UNITED STATES PATENT AND TRADEMARK OFFICE

APPLICATION NO.	FILING DATE	FIRST NAMED INVENTOR	ATTORNEY DOCKET NO.	CONFIRMATION NO.
10/783,499	02/20/2004	George Gustave Zipfel JR.	Zipfel 1	7599
7590 Ronald D. Slusky 353 West 56th St.-Suite 5L New York,, NY 10019-3775		03/09/2007	EXAMINER SHINGLETON, MICHAEL B	
			ART UNIT 2815	PAPER NUMBER
SHORTENED STATUTORY PERIOD OF RESPONSE 3 MONTHS		MAIL DATE 03/09/2007	DELIVERY MODE PAPER

Office Action Summary

DETAILED ACTION

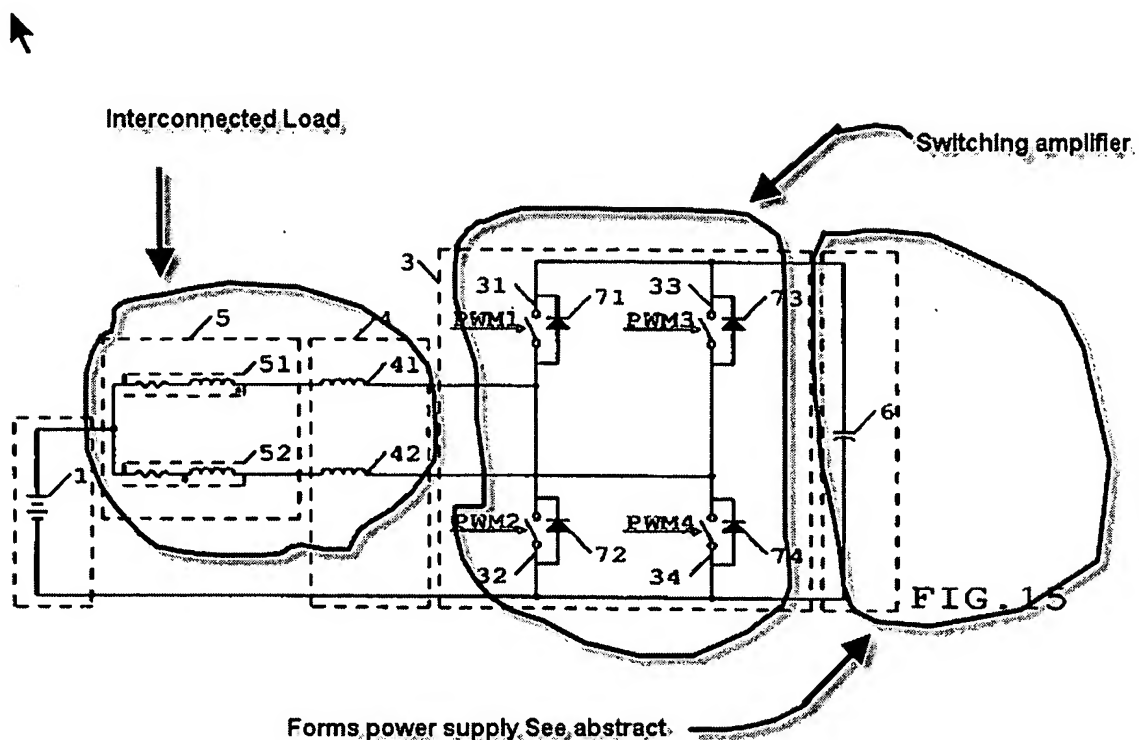
Above shows the elected invention of Figures 4a and 4b. The interconnected load for the switching amplifier is shown above. While the claim lacks any detail of the switching amplifier itself, the examiner has attempted to apply art to these omnibus claims. The examiner has cited Prokin of record for

As recited by Prokin the bridge capacitor 6 supplies the power for the switching amplifier (See the abstract and the relevant text in the specification of Prokin.). As one can see from the above drawings the switching amplifier of Prokin is the same structure as that of applicant's elected invention. Note the four transistors. Thus the claimed structure to the switching amplifier is anticipated by Prokin in so far as the claims are understood. Note that the switching amplifier has output lines to the interconnected load and thus these are means for applying the baseband components. Note the common power supply node of element 1 of Prokin. Note that the switching amplifier of Prokin has "at least one power supply terminal" in the bridge capacitor or element 1 as set forth by at least claim 14. The four transistors like that of applicant's four transistor structure switching amplifier produces an alternating polarity of currents (See claim 22 of the instant application.). The use of PWM signals do not define any switching amplifier structure but never the less Prokin has PWM signals applied to the four transistors that make up the switching amplifier structure. The output lines are the means for supplying the two switching signals to

the switching amplifier is the same as that noted above. Below the examiner has provided a copy of Figure 15 of Prokin.

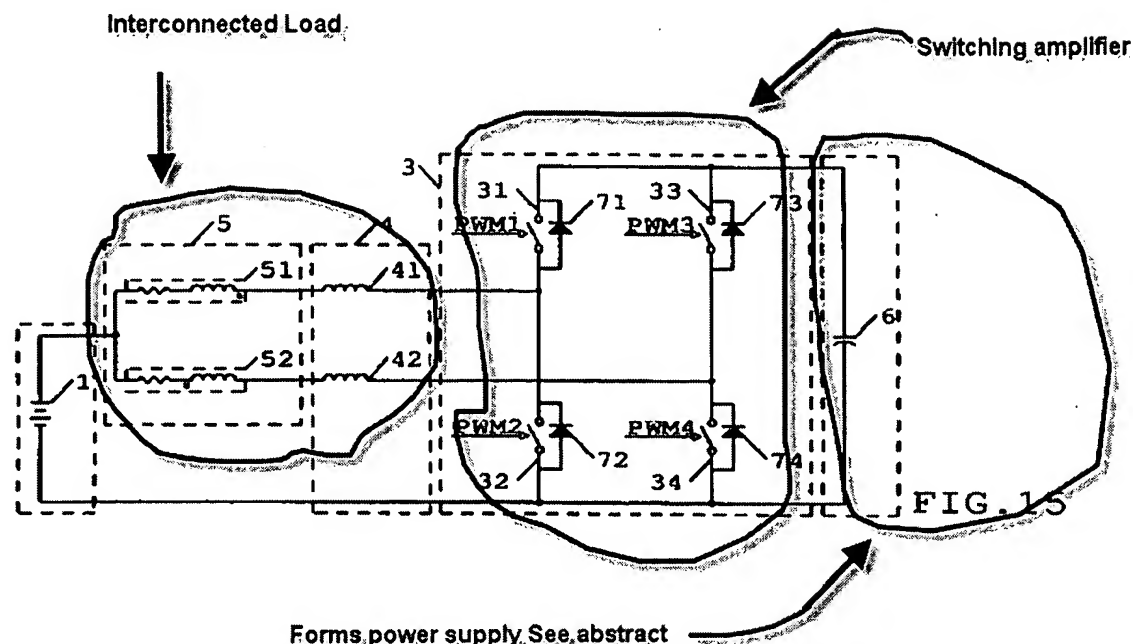
the interconnected load (See claim 24 of the instant application.) The examiner contends that while the load set forth in the claims is not part of the claimed structure of the switching amplifier, if one were to connected the interconnected load to the switching amplifier of Prokin this would result in the combination functioning exactly as that of applicant's combination of switching amplifier and interconnected load. Thus the switching amplifier structure meets the claimed switching amplifier structure set forth in the above indicated claims.

As can be seen from Figure 15 of Prokin the apparatus has two circuit paths that include at least a reactive load of 41, 42, 51 or 52. The switching amplifier is identical to that claimed as noted in the above rejection(s). There is a PWM generator or drive as indicated by the PWM signals in Prokin. Note that the loads of Prokin do form at least one transducer as elements 51 and 52 are voice coils (See column 8, around line 22). Also note that the common node of the loads of Prokin is connected to the DC voltage source 1 in the same manner that the common node of the loads L1 and L2 are connected to the DC voltage source V_1 . Prokin is silent on the specific circuit values that enables the recited function where substantially all of the current at baseband frequencies flowing in the two circuit paths flows through the respective reactive load. This is merely defining the workable range for the arrangement. It would have been obvious to one of ordinary skill in the art at the time the invention was made to have adjusted the values of these components so as to ensure the claimed functional language is provided for as these functions are merely part of the workable / optimum range for the device and it has been long held that where the general conditions of a claim are disclosed in the prior art discovering the optimum/workable range involves only routine skill in the art.
